U.S. DEPARTMENT OF ENERGY

WAVES TO WATER

WEBINAR COMPETITOR QUESTION RESPONSES ADAPT STAGE

Provided by the Coastal
Studies Institute

**Primary mooring
Jennette's Pier**

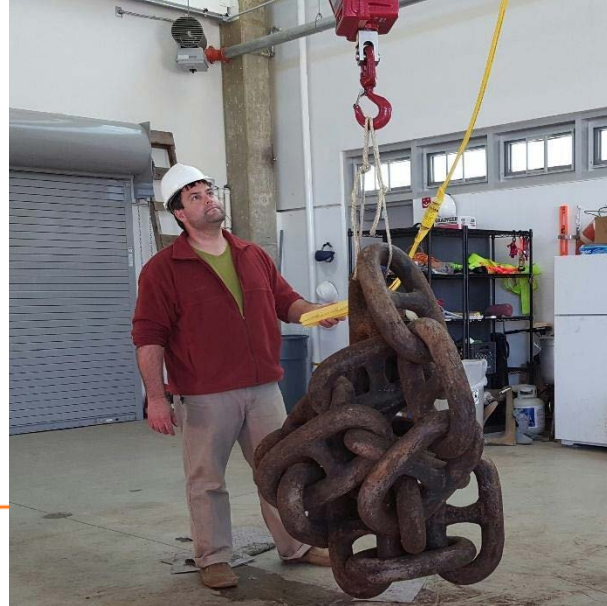
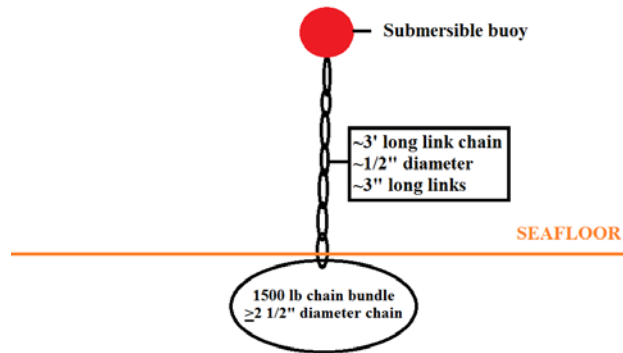
12. Can weight be added to that primary anchor (with material we would bring inside the container)?

13. Is the primary anchor allowed to lift off slightly, as long as it does not leave a defined area?

- 14. In the official test site information, the anchor will be approximately 1,000 lbs. Is it possible to use the anchor as the ballast weight on the system? That means teams can put the chain bundle (i.e. anchor) on the system to stabilize the system.**

Response: No, adding weight will complicate the installation of the standard mooring.

Response: Please note any designed anchor lift could pose a significant risk to water and/or electrical connections provided for each competitor at their specified test berth. Currently, the prize team is analyzing specifying a minimal allowable anchor lift that will work safely

with provided water and/or electrical connections. Competitors should proceed cautiously and assume only minimal amounts of anchor lift if necessary, however more prudent would be to assume no anchor lift.

Response: The approximate dry weight of the anchor will be 2000 lbs (See Adapt Stage – Waves to Water Rules and Criteria Revision 1). Systems that utilize the standard mooring as ballast or as an integrated structural component of their system design will be reviewed by CSI for approval. The prize team cannot guarantee these concepts will be approved or considered feasible.
